Notice of Proposed Amendment 2016-04

Maintaining aerodrome rules

CS ADR-DSN — Issue 3

RMT.0591 — 14.6.2016

Figure C-1. Runway starter extension strip

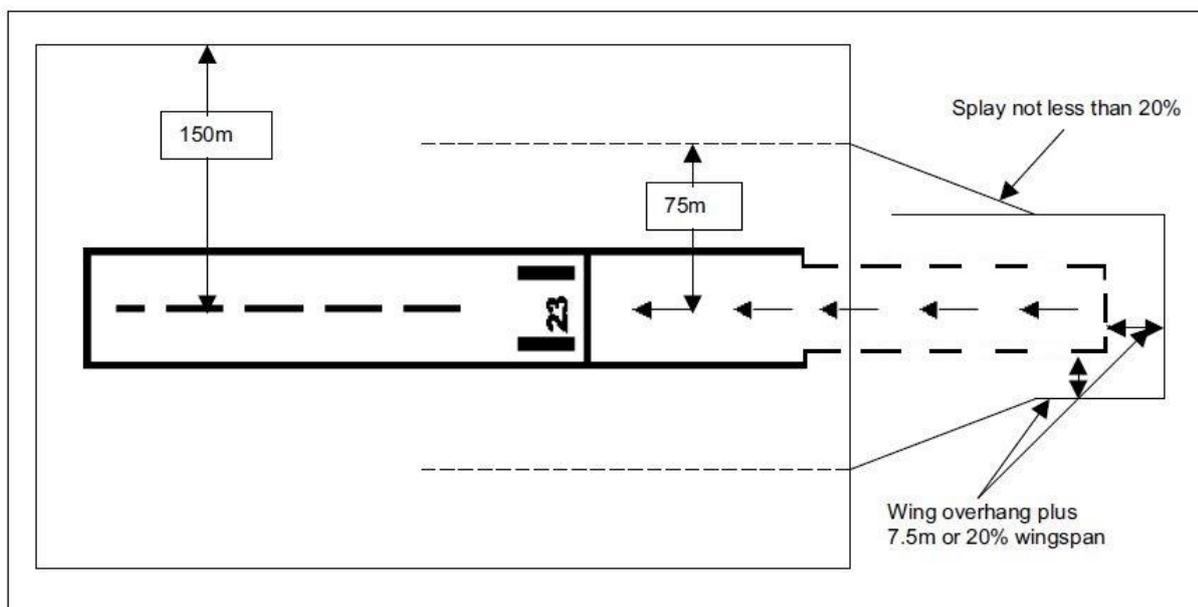
- (1) Length of the runway starter extension strip should be provided to cover wing overhang of the largest aeroplane plus a safety margin of 7.5 m or 20 % of wingspan of the largest aeroplane, whichever is greater (see Figure C-1).
- (2) Width of the runway starter extension strip should be the same as associated runway strip on its inner edge and may be reduced towards its outer edge to provide a distance from each edge of the runway starter extension to cover wing overhang of the critical aeroplane plus 7.5 m or 20 %

of wingspan of the largest aeroplane, whichever is the greater (see Figure C-1). The splay of this reduction should not be less than 20 %.

Figure L-5A. Marking of the runway starter extension

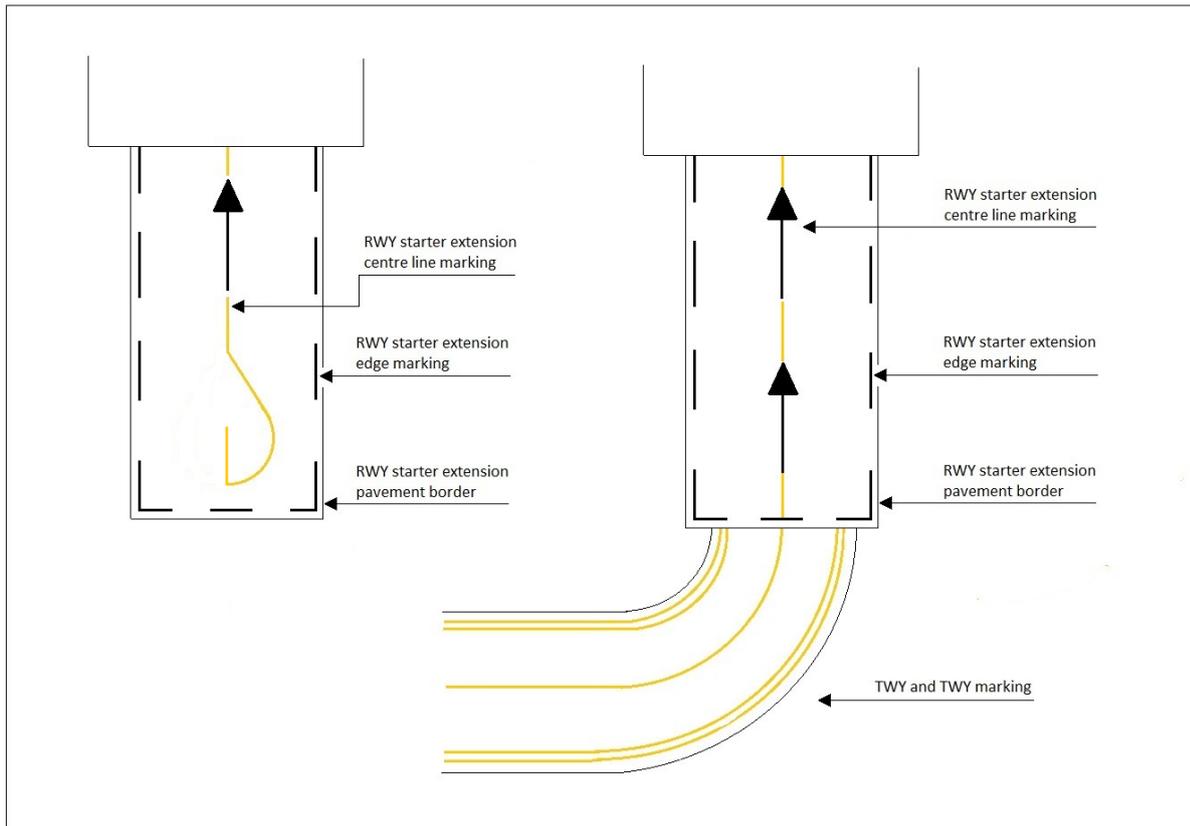
New requirements for marking of runway starter extension are added. Where the end of the runway starter extension is not associated with the taxiway, the centre line of the runway starter extension should indicate the path for the aeroplane to make a turnaround. This requirement is not associated to the 'runway turn pad' requirements as provided in CS ADR-DSN.B.095. The aerodrome operator is free to design a turnaround for an aeroplane, however, taking into account all safety requirements, particularly related to the clearances.

- (c) Characteristics:
 - (1) Edge marking of the runway starter extension should be dashed white line (see Figure L-5A).
 - (2) Centre line marking of the runway starter extension should be yellow and be at least 15 cm in width.

Figure L-6. Enhanced taxiway centre line marking

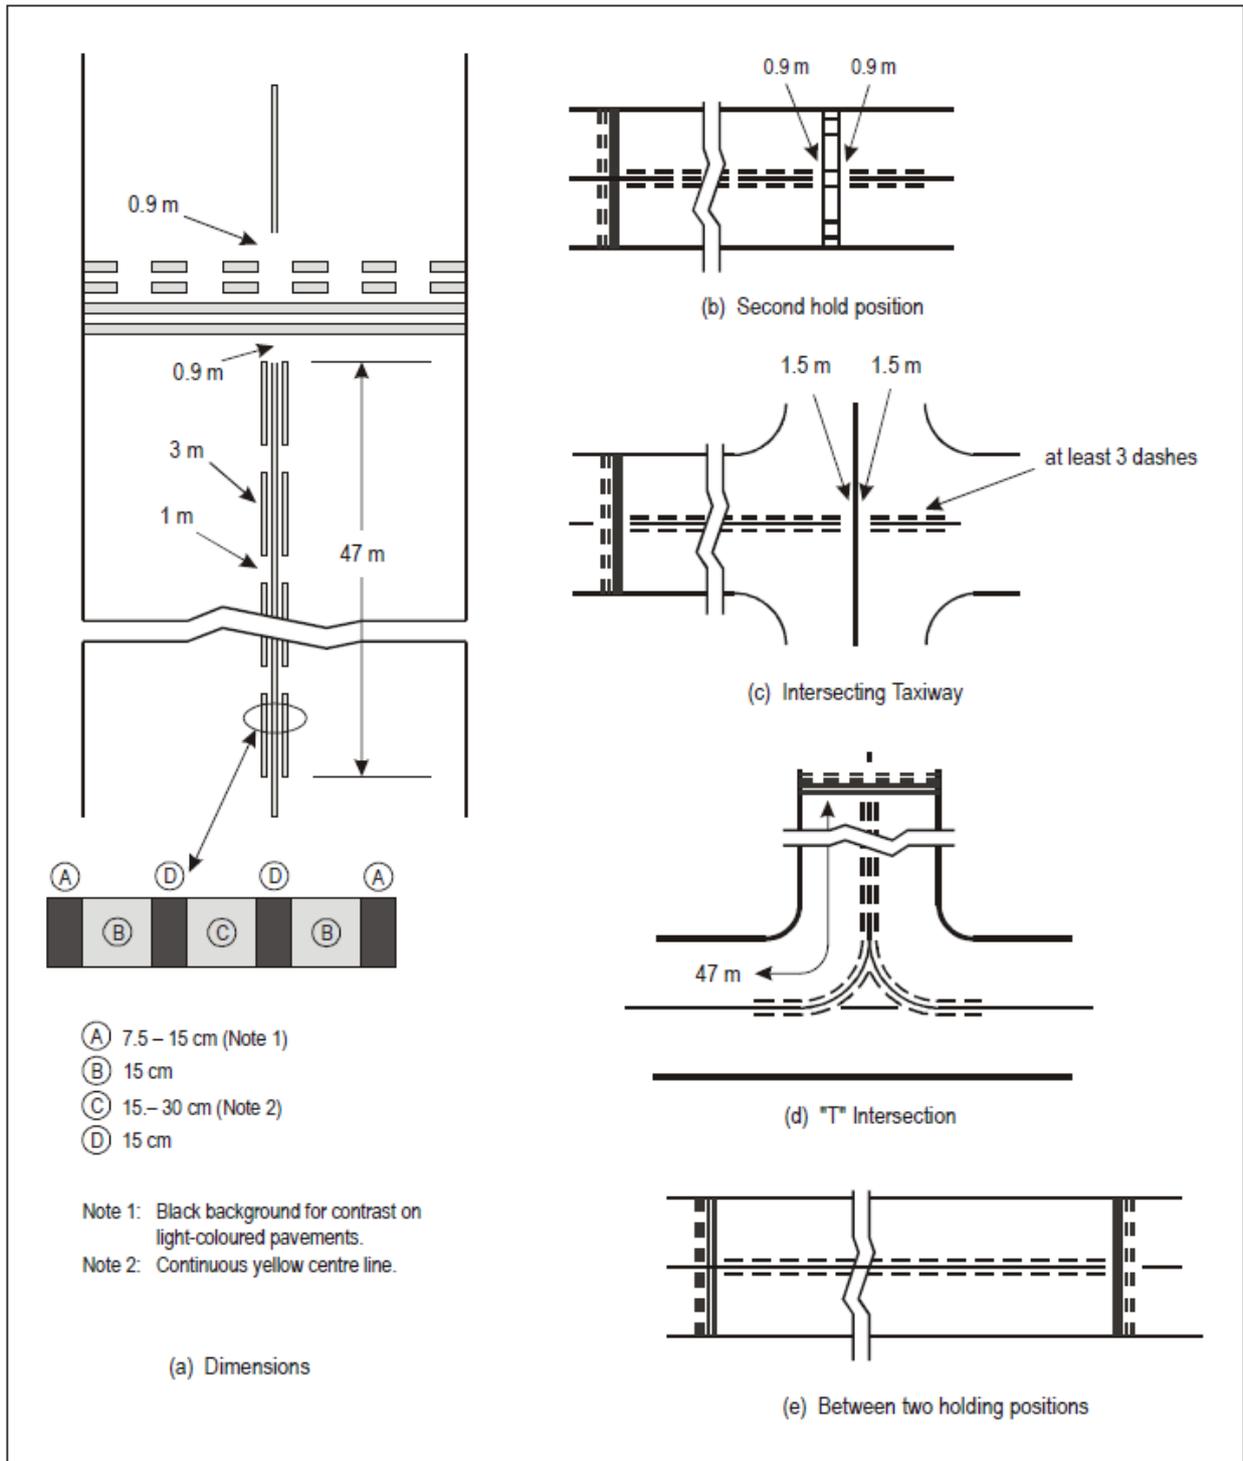
The requirements of enhanced taxiway centre line marking are updated in line with the ICAO Annex 14 (Amendment 11). The proposed amendments adopt a slightly different wording, but the meaning remains the same. At the same time they correct the extend of the enhanced taxiway centre line (47 m instead of 45 m due to mathematical errors) and the requirements concerning its location which become more detailed, but without having any impact.

[Editorial Note: Remove exiting Figure L-6]

[Editorial Note: Insert new Figure L-6]

- (b) **Characteristics:**
- (1) Enhanced taxiway centre line marking should be as shown in Figure L-6. An enhanced taxiway centre line marking should extend from the runway-holding position Pattern A (as defined in Figure L-5) to a distance of up to 47 m in the direction of travel away from the runway (see Figure L-6(a)).

Figure L-9. Mandatory instruction marking

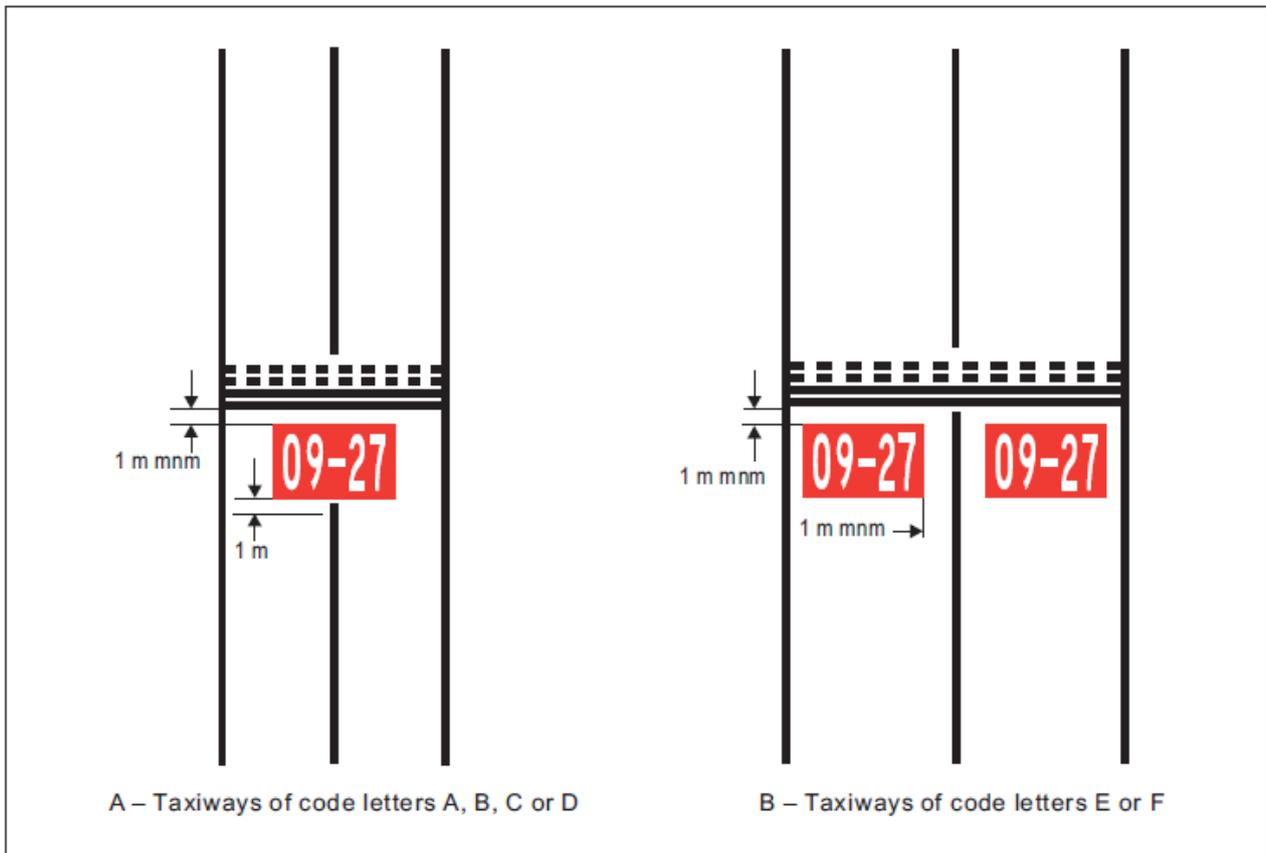
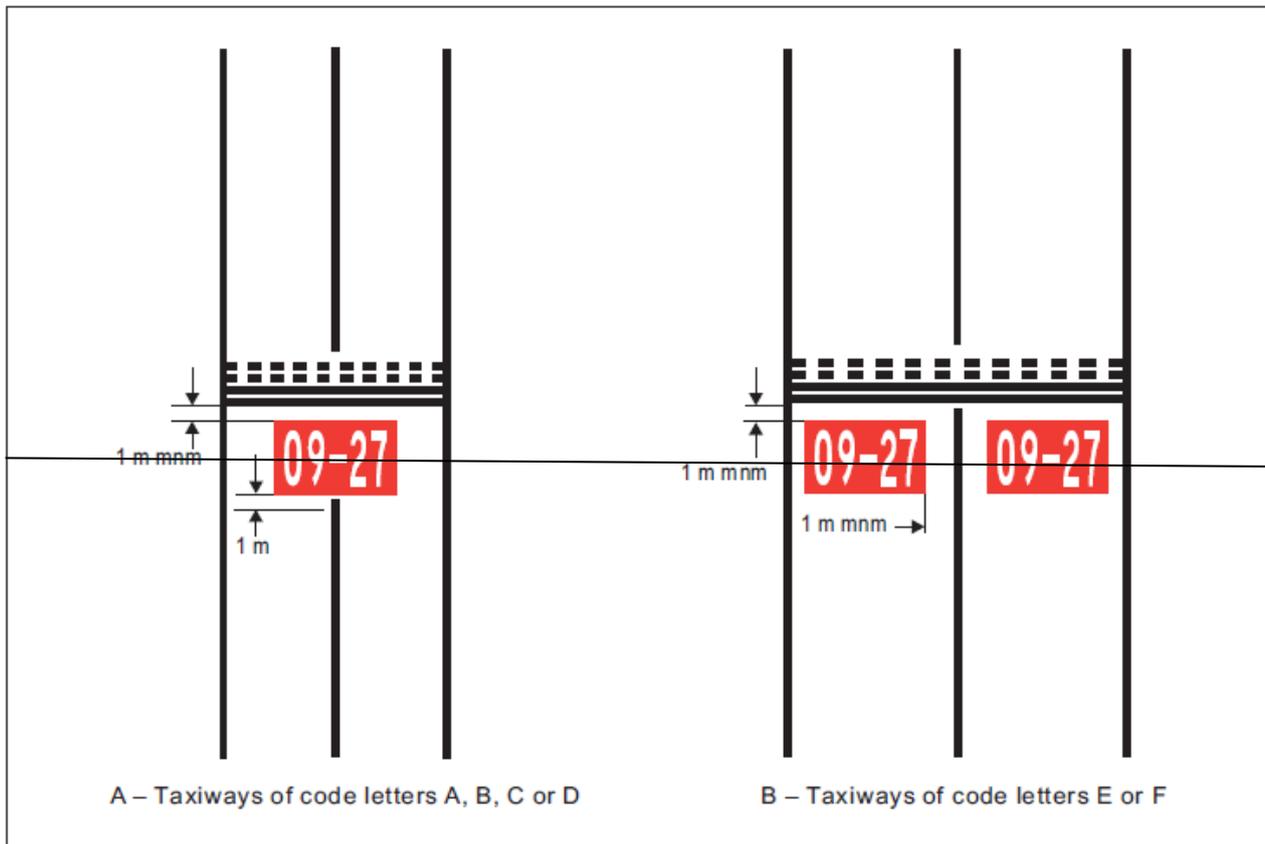
The unchanged Figure L-9 is moved to the appropriate position.

Figure M-2. Precision approach Category I lighting systems

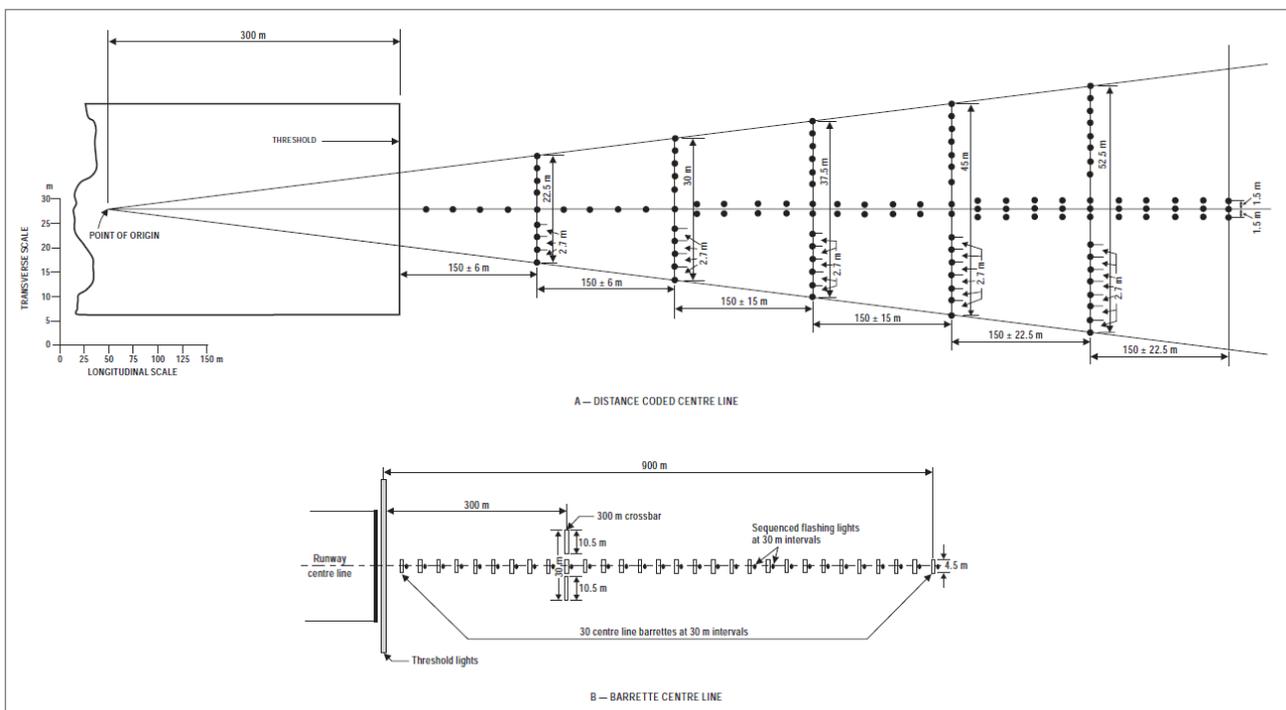
For better clarification, in paragraph (b) (1) the reference to the Figure M-2 and corrections of typos are provided.

In the title of Figure M-2 correction of a typo is provided.

- (1) General: A precision approach eCategory I lighting system should consist of a row of lights on the extended centre line of the runway extending wherever possible, over a distance of 900 m from the runway threshold with a row of lights forming a crossbar 30 m in length at a distance of 300 m from the runway threshold (see Figure M-2).

Figure M-4. Siting of PAPI and APAPI

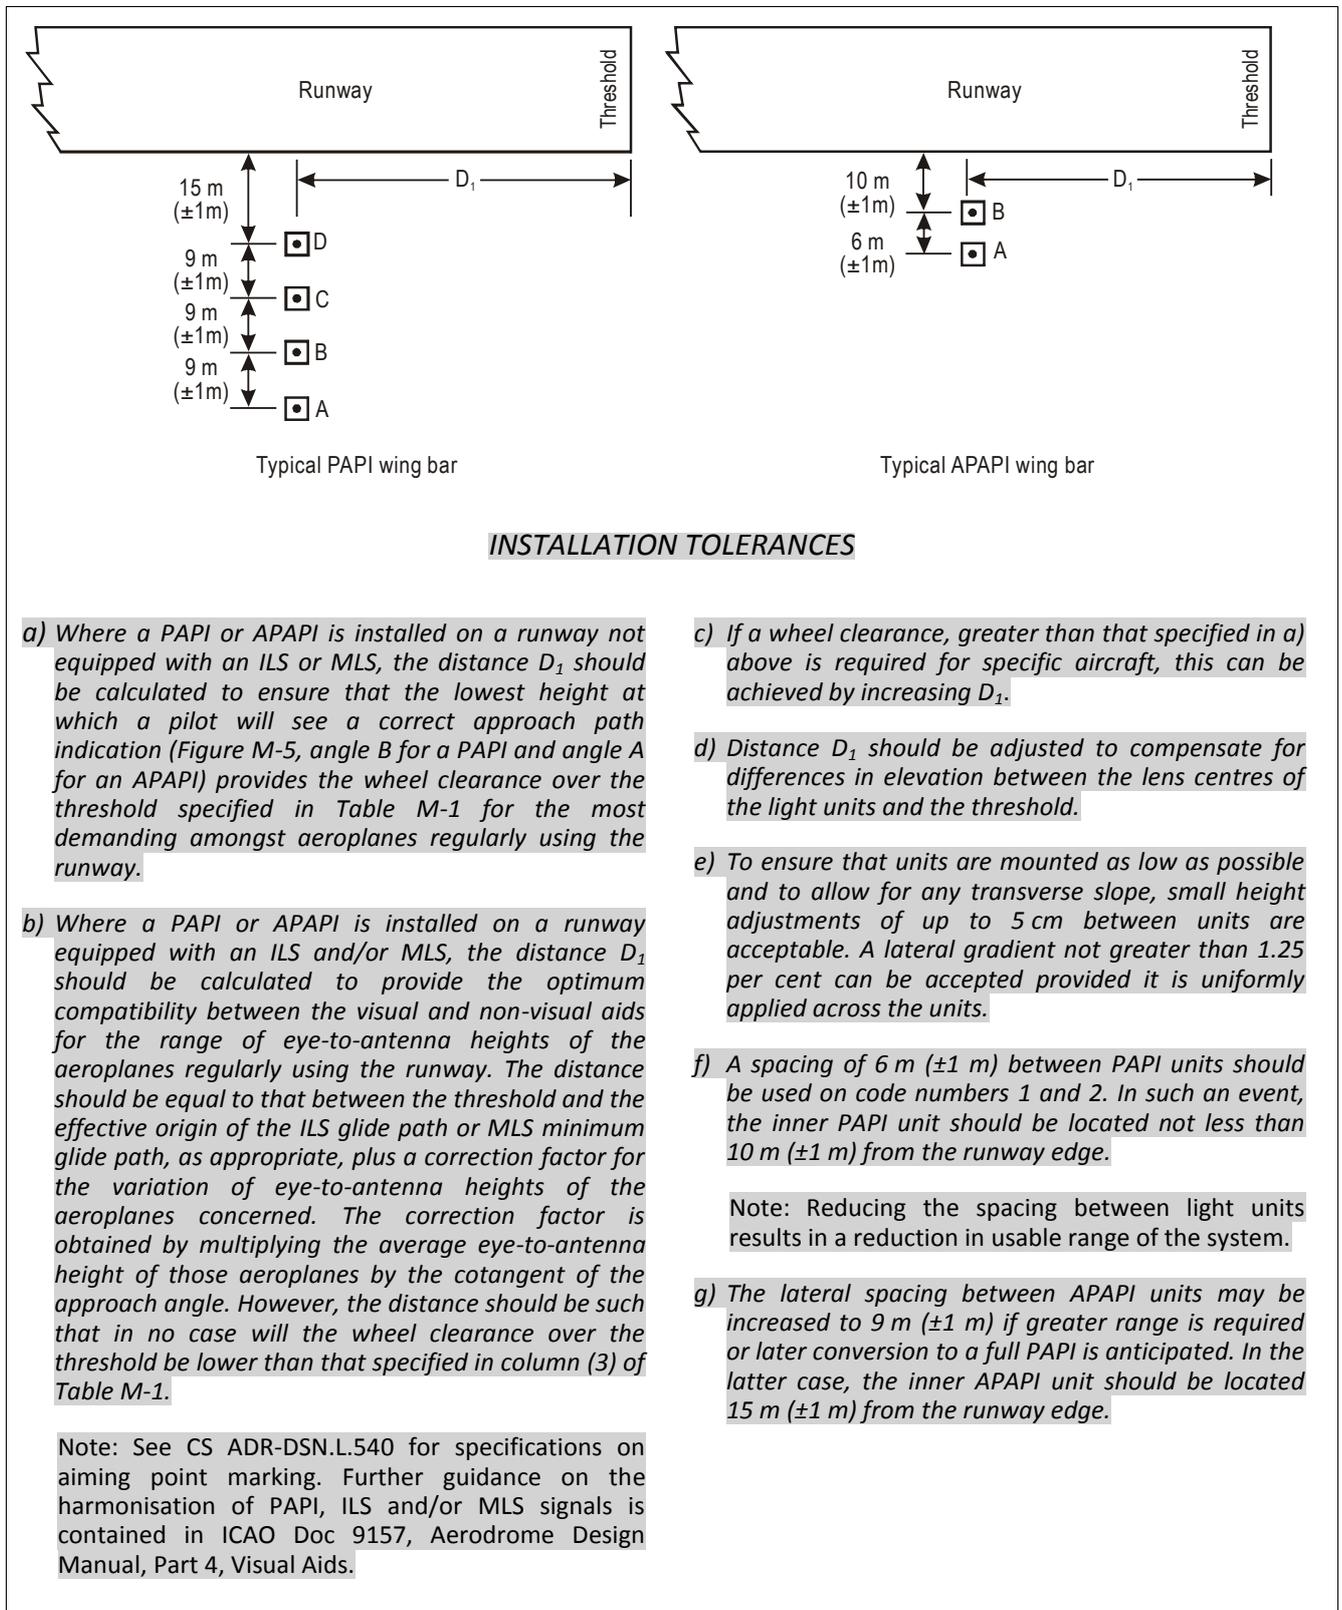
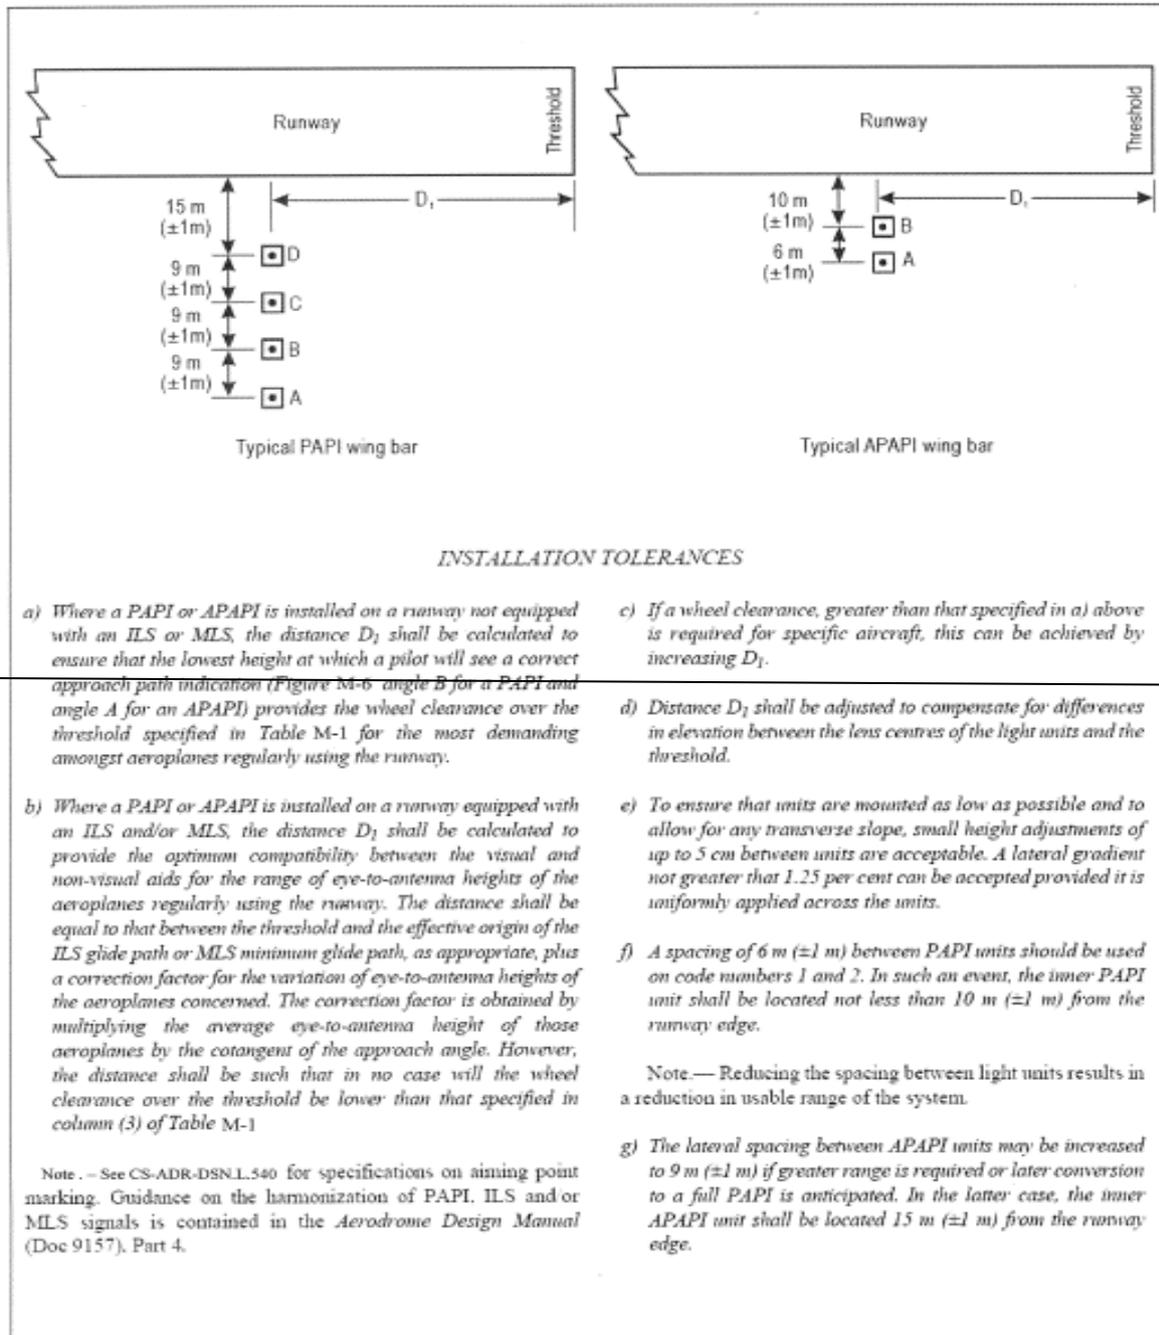
A new Figure M-4 is provided with better quality, without any change to its content.

[Editorial Note: Insert new Figure M-4]

[Editorial Note: Remove existing Figure M-4]
